# Certificate of Appropriateness

Masonry road bridge at the far north end of Lake Park over the ravine.

PTS ID 56977 COA. masonry road bridge in Lake Park

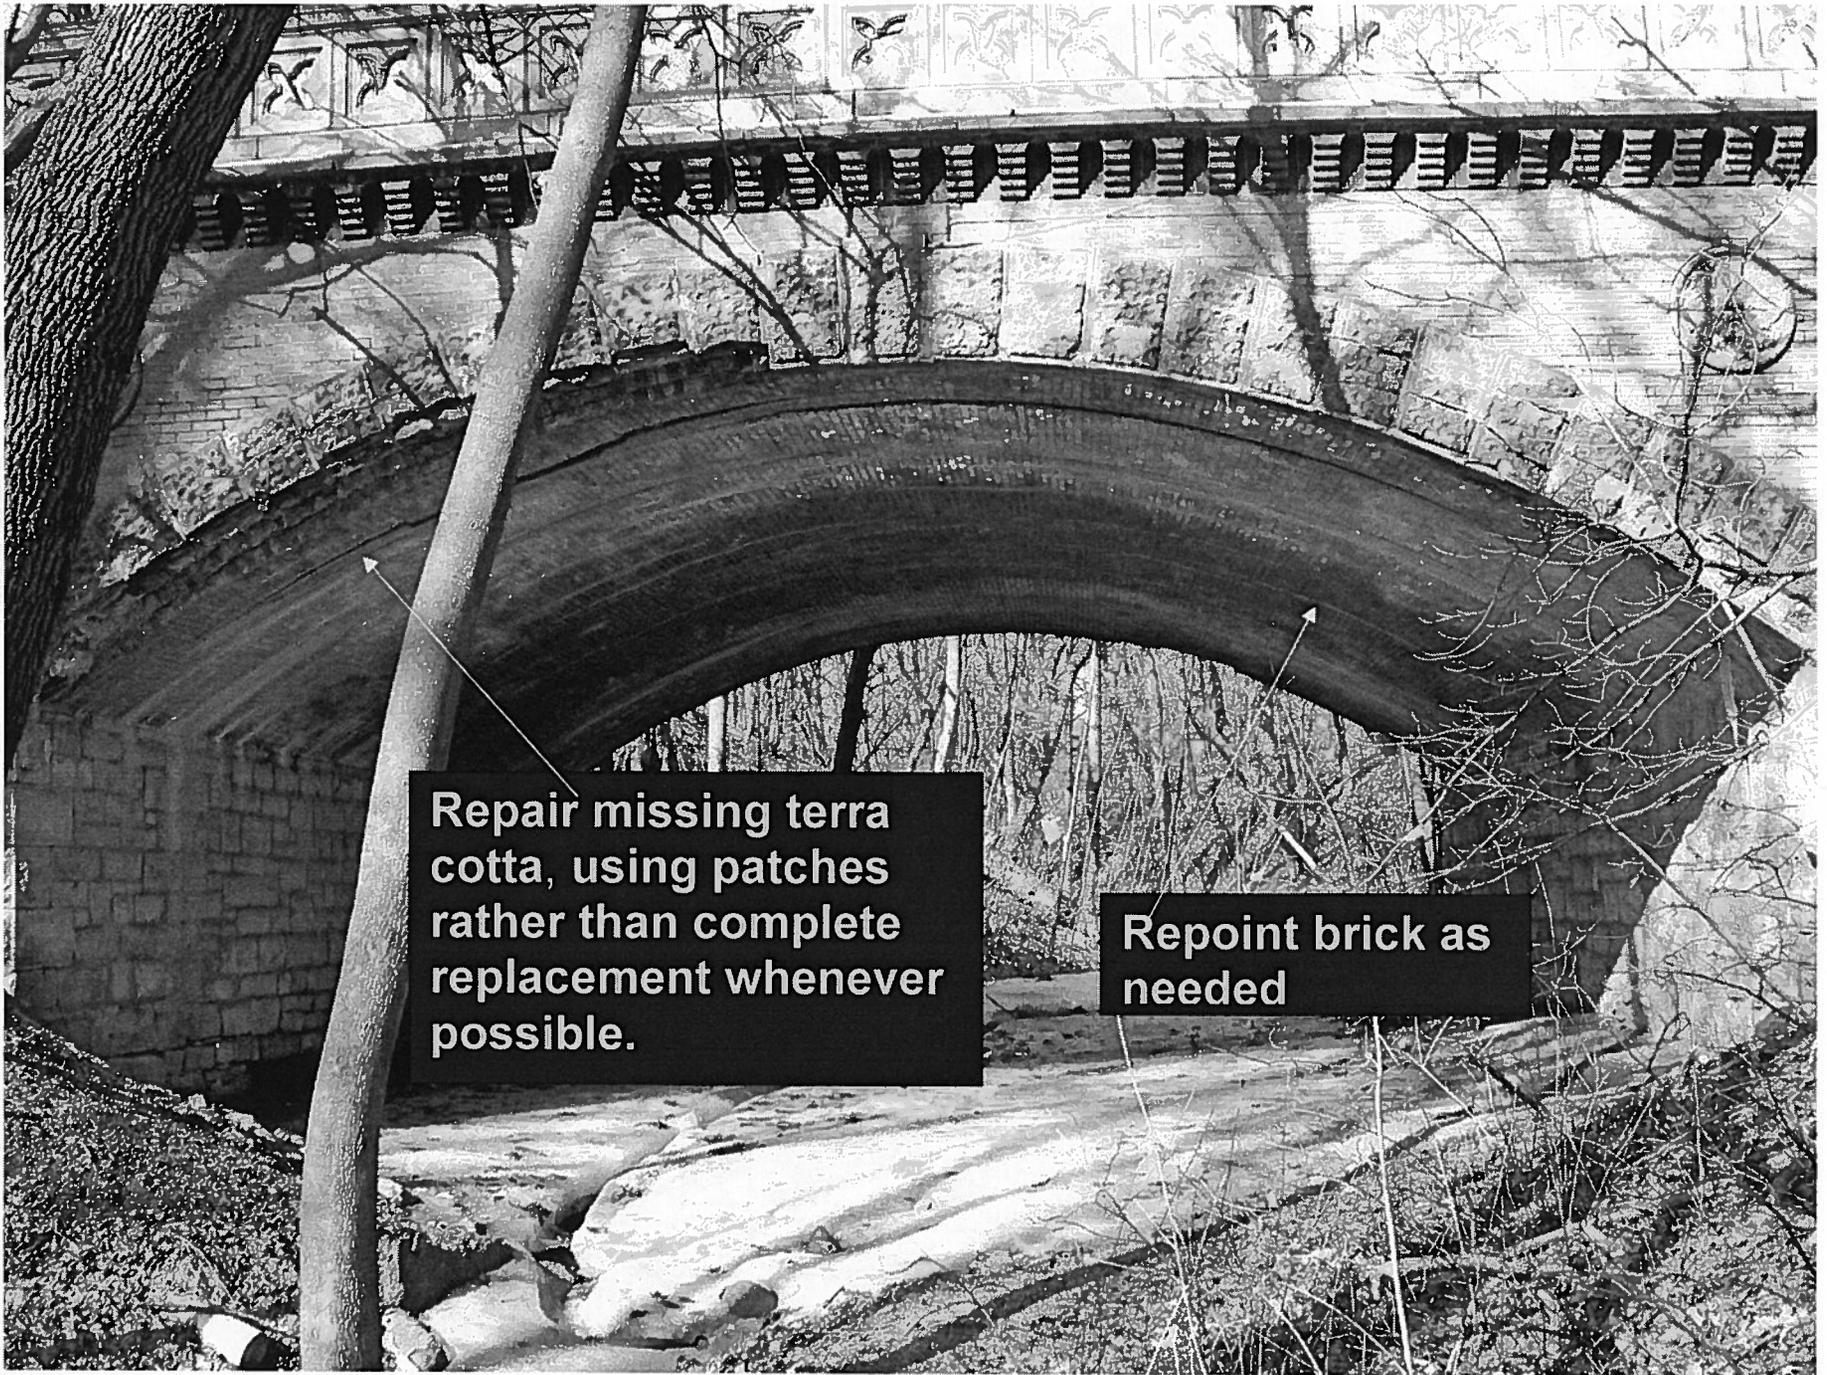
Spalled terra  
cotta to be  
replaced with  
matching  
pieces made in  
cast concrete

**Repair missing terra cotta, using patches rather than complete replacement whenever possible.**

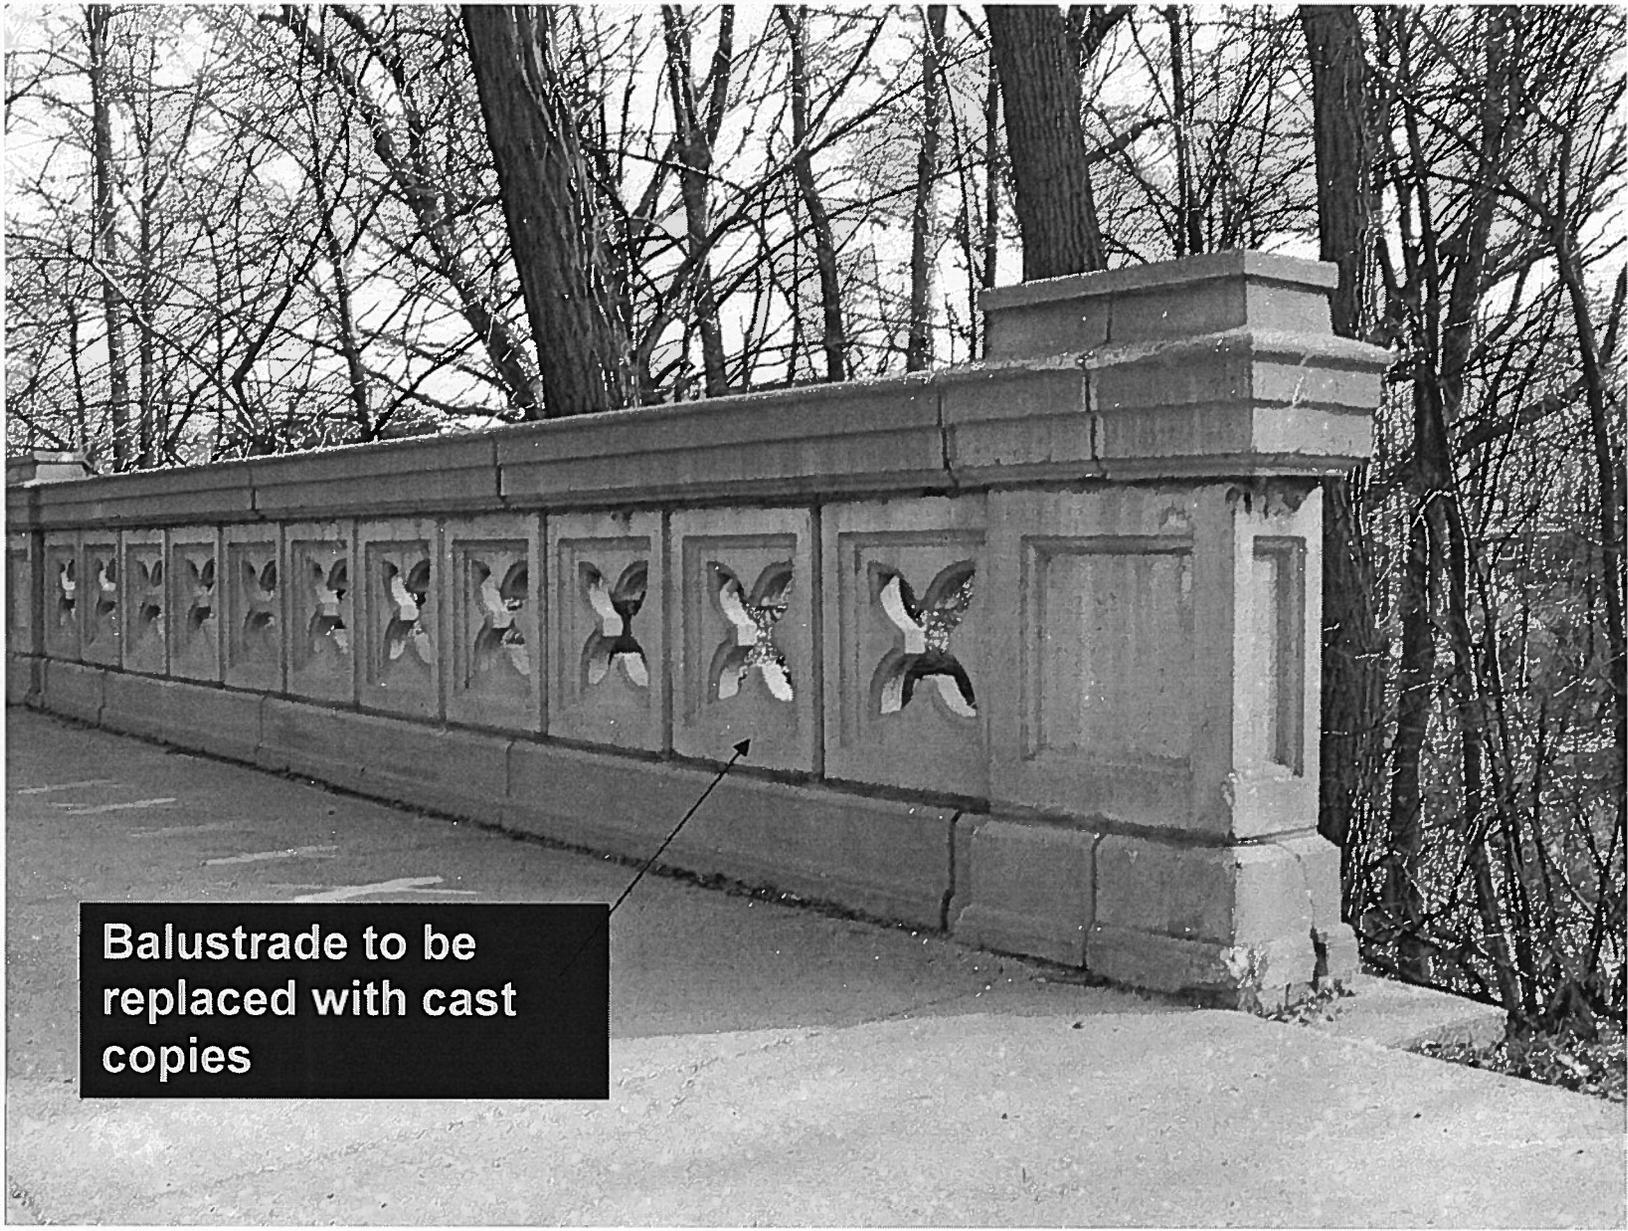
**Repoint brick as needed**

**Balustrade to be  
replaced with cast  
copies**
